Amendments to the Drawings

Attached are replacement drawing sheets for Figures 1 and 2 of this application. The following changes are contained on the replacement drawings.

FIG. 1 (PRIOR ART)

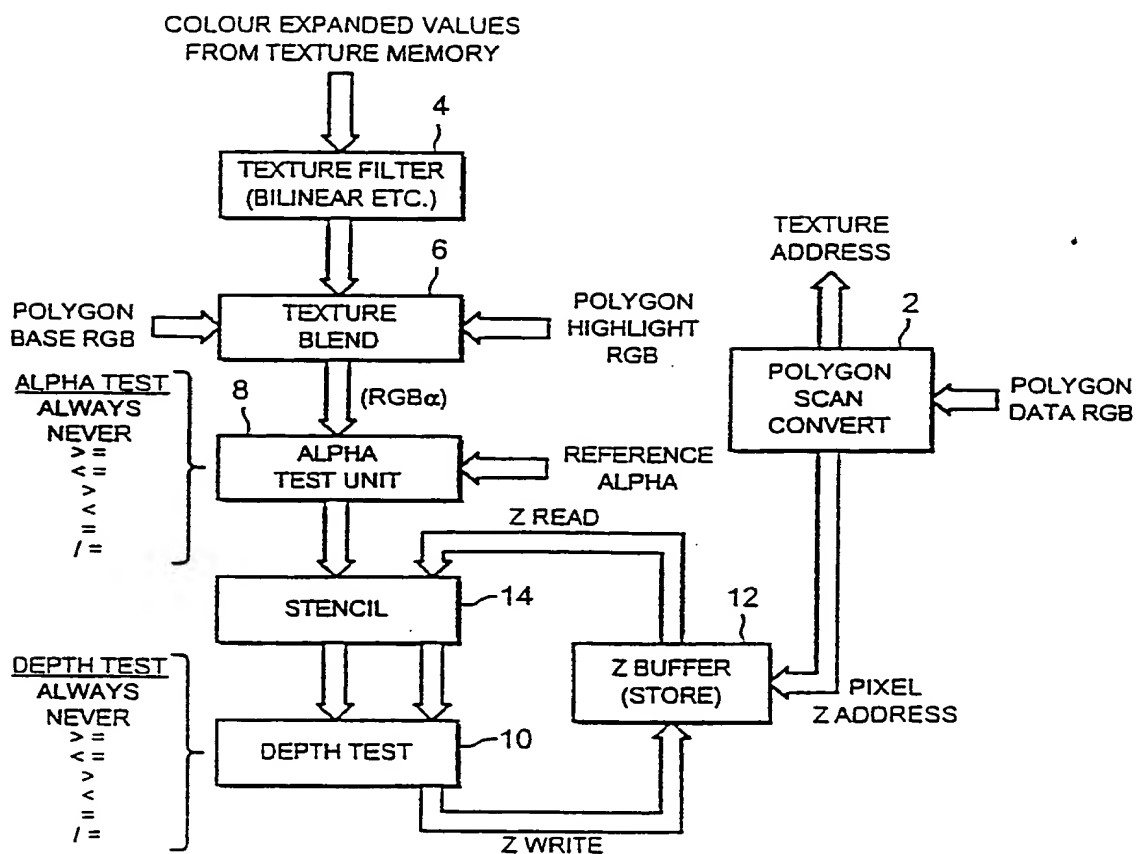
Figures 1 and 2

The legend "PRIOR ART" is added to these drawings to indicate that, as set forth in the application, these drawings are directed to prior art technology. (Original Specification, page 5, lines 25-28.)

FIG. 2 (PRIOR ART)

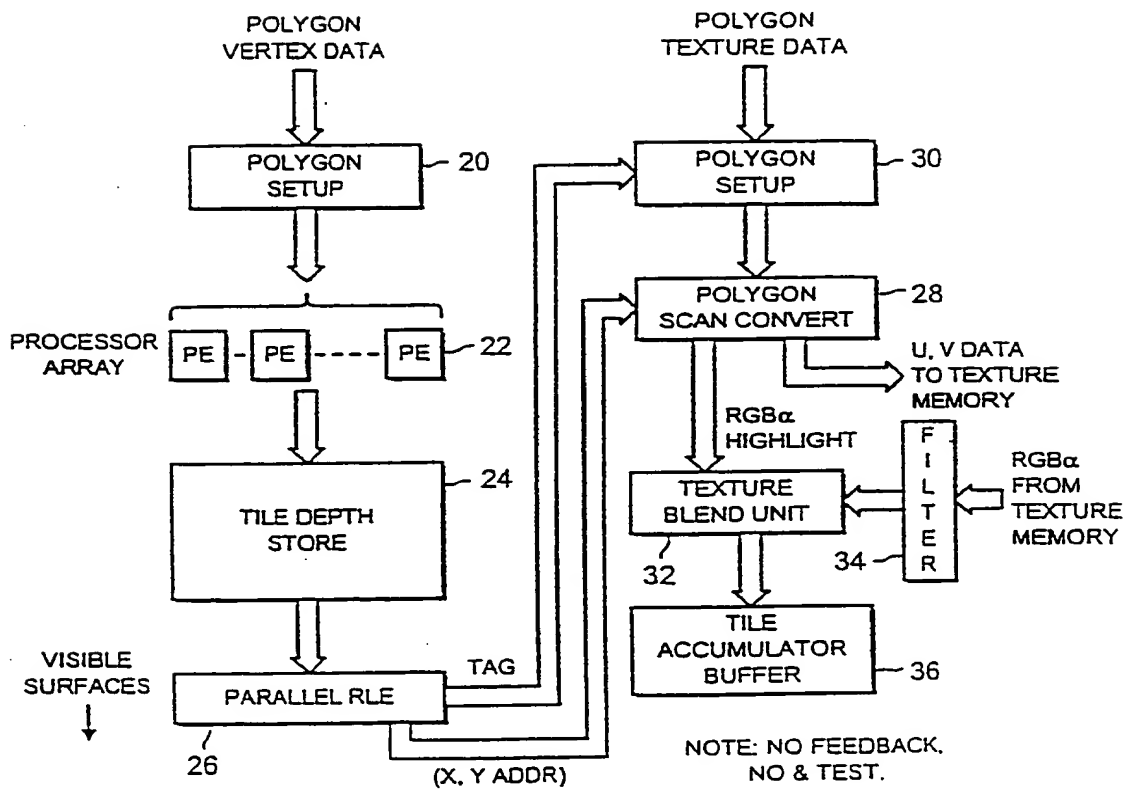
Figure 2

Change the identification number associated with the polygon scan convert unit from "38" to "28". This change is made to identify this component consistent with the identification number employed in the application. (Original Specification, page 4, lines 13-14.)
